UNLESS OTHERWISE SPECIFIED: DIMENSIONS ARE IN INCHES		Pinnacle Systems, Inc.	
DECIMALS	± .05	SIZE	FSCM NO.
ANGULAR	± 0.5°	DWG NO.	28-160
DO NOT SCALE DRAWING		SCALE	REV
DRAWN	DATE	4 Sided guarding	
CHECKED			
DESIGN

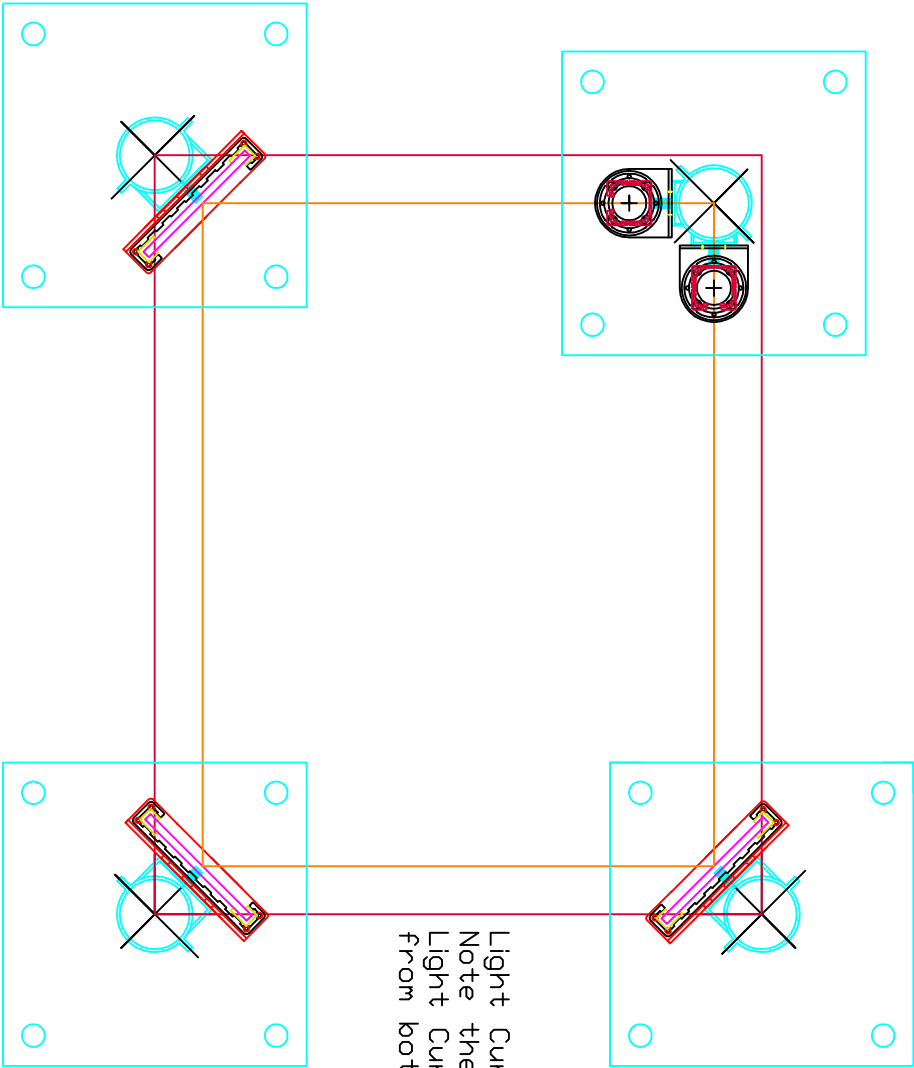
Light Curtain & Mirror setup for 4 side guarding
 Note the light curtain offset from the Mirrors
 Light Curtain Pedestal needs to be moved in by 1.58"
 from both directions
